# Work Order ID 76828

Item Name: Crosstube Turning Detail

DRAWING NO. D212-664-247	TITLE CROSSTUBE ASS'Y (205 LOW AFT)	REV. B	<b>DART AEROSPACE LTD ENGINEERING ORDER</b>		D.E.O. NO. D212-664-247-B-1	SHEET NO. SHEET 1 OF 1	SCALE NTS
DRAWN <i>q</i>	CHECKED <i>ASS</i>	MFG. APPR. <i>AB</i>	APPROVED <i>MD</i>		DE APPR. <i>AB</i>		
DATE 11.07.15	DATE 11.07.20	DATE 11.07.21	DATE 11/07/21		DATE 11.07.21

**PURPOSE:**  
REPLACE MAGNOBOND WITH PROSEAL.

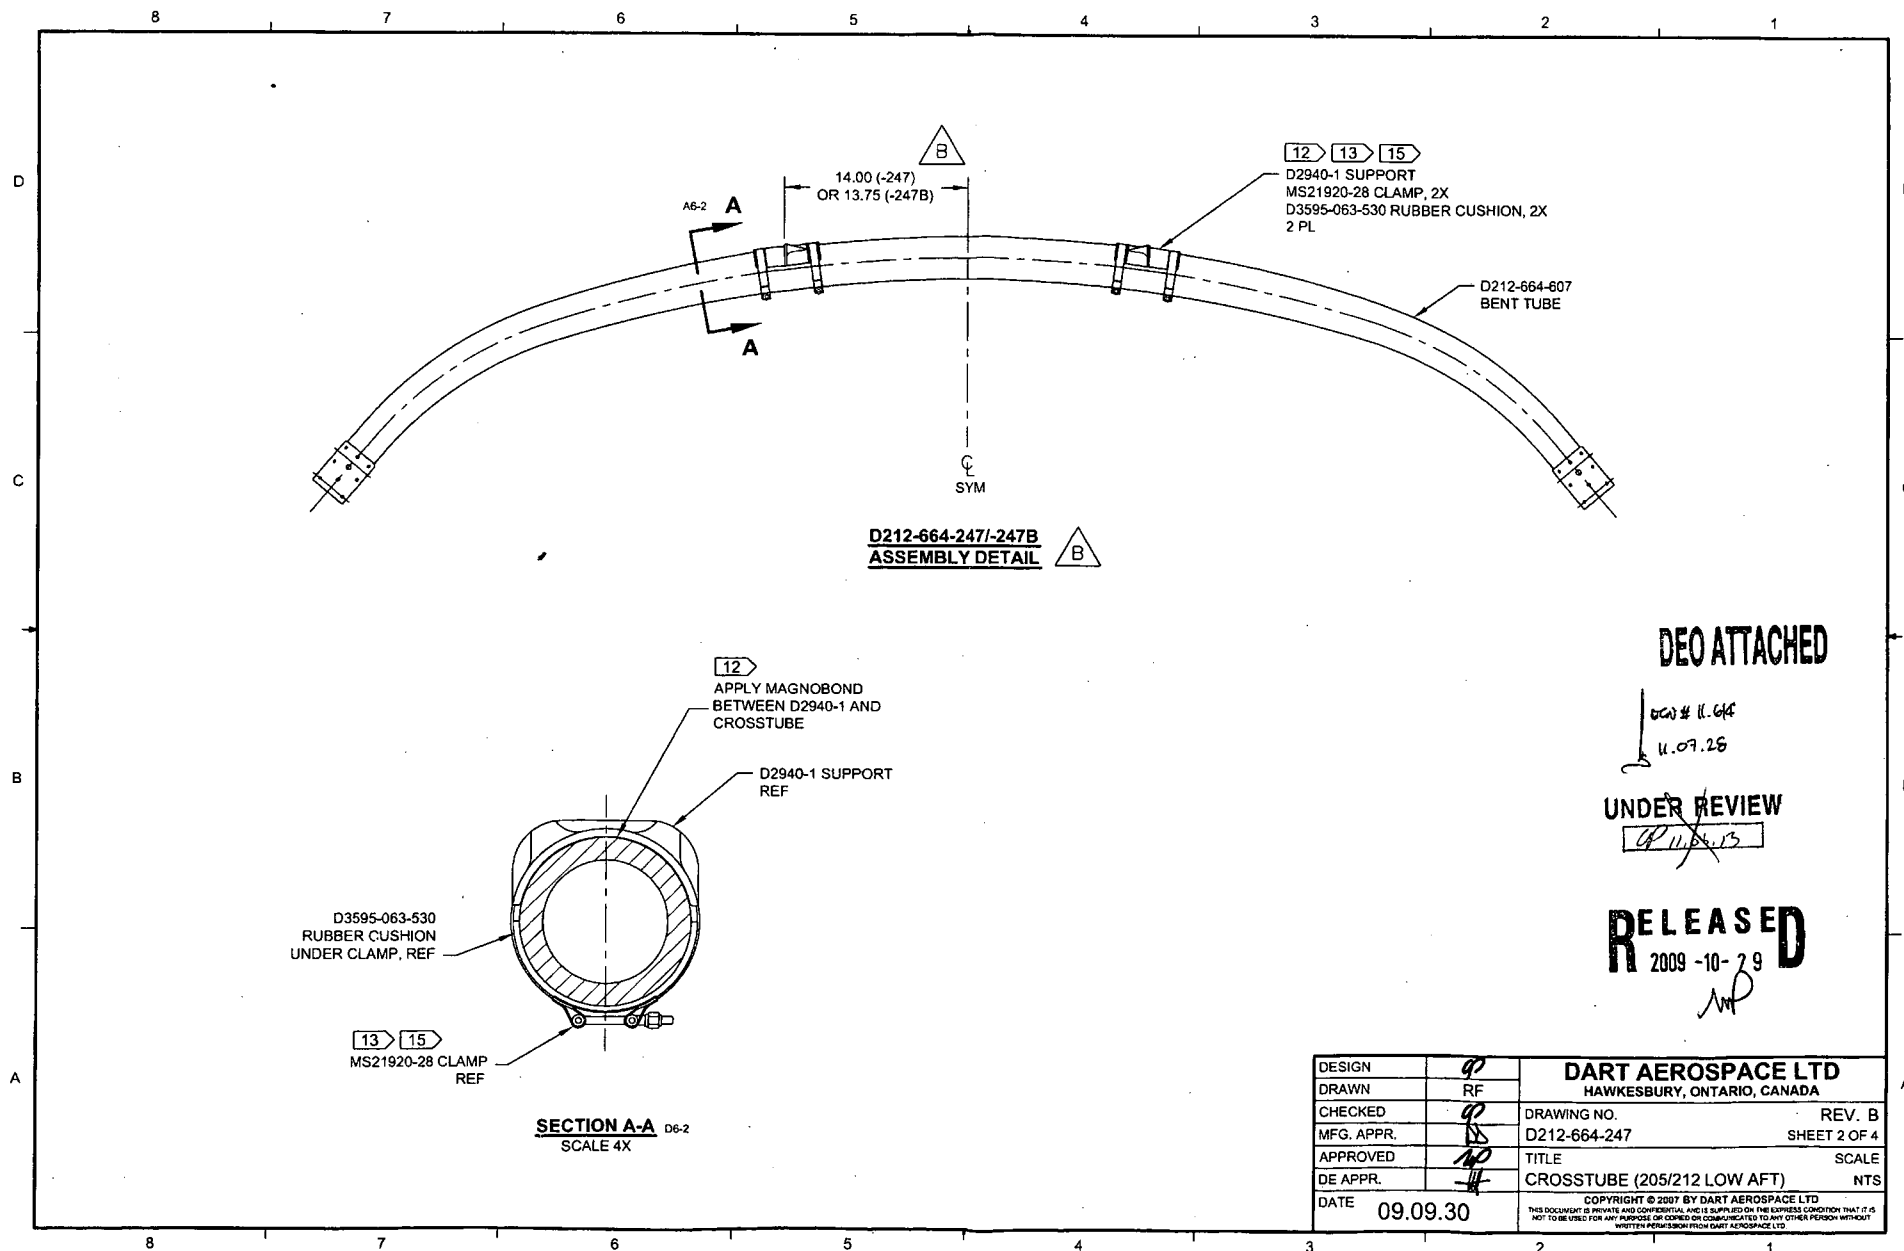
IS:

Item	Qty -247	Qty -247B	Part Number	Description
9	A/R	A/R	PROSEAL 890 B-2	SEALANT, AMS-S-8802 CLASS B-2

WAS:

9	A/R	A/R	MAGNOBOND 6398	ROCKWELL SPECIFICATION RBO-120-023 ADHESIVE (TEXTRON/BELL SPEC. 299-947-100, TYPE II, CLASS 2 ADHESIVE)
---	-----	-----	----------------	---

NOTE 12 & 15, SHEET 1 IS AMENDED AS FOLLOWS:

WAS:

12) INSTALL D2940-1 SUPPORT USING 0.03" TO 0.06" THICK LAYER OF MAGNOBOND 6398 TO THE SURFACE OF D2940-1 THAT WILL BE IN CONTACT WITH THE CROSSTUBE PER QSI 015. LET CURE FOR 12 HOURS AFTER INSTALLATION AND PRIOR TO PACKAGING.

15) TORQUE CLAMPS 80 TO 100 IN-LB. ENSURE AT LEAST 1.5 THREADS SHOWING IN SAFETY AND THAT NUT HAS NOT BOTTOMED-OUT AFTER TORQUING.

IS:

12) TO INSTALL D2940-1 SUPPORT: ABRABE MATING SURFACE OF SUPPORT AND CROSSTUBE WITH 180-GRIT SANDPAPER AND REMOVE RESIDUE WITH MEK (OR EQUIVALENT). APPLY A 0.04" TO 0.07" THICK LAYER OF PROSEAL 890 CLASS B-2 (OR AMS-S-8802 CLASS B-2) SEALANT TO MATING SURFACE OF SUPPORT.

15) TORQUE CLAMPS 80 TO 100 IN-LB. ENSURE AT LEAST 1.5 THREADS SHOWING IN SAFETY AND THAT NUT HAS NOT BOTTOMED-OUT AFTER TORQUING. **PRIOR TO PACKAGING, RE-CHECK TORQUE ON CLAMPS AFTER PROSEAL 890 SEALANT HAS CURED FOR 72 HOURS.**
